ORIGINATION FORM

Proposed Revisions to a Standard Plans Index (Please provide all information — Incomplete forms will be returned)

Index Number: 700-011

Index Title: Single Column Cantilever Ground Mounted Sign

SECTION C-C

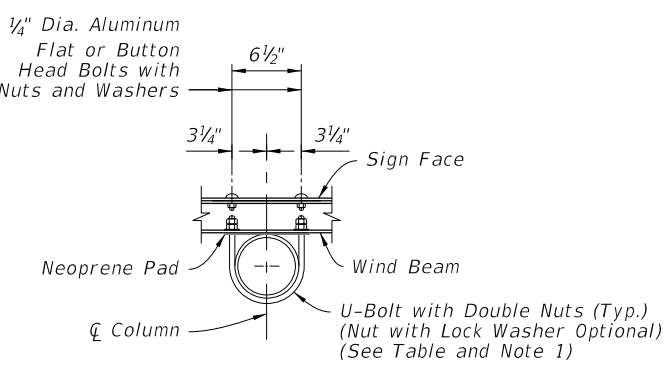
Sheet 1: Added nut and lock washer option to SECTION C-C.

Districts have commented that double nuts are more difficult to install with negligible safety benefits.
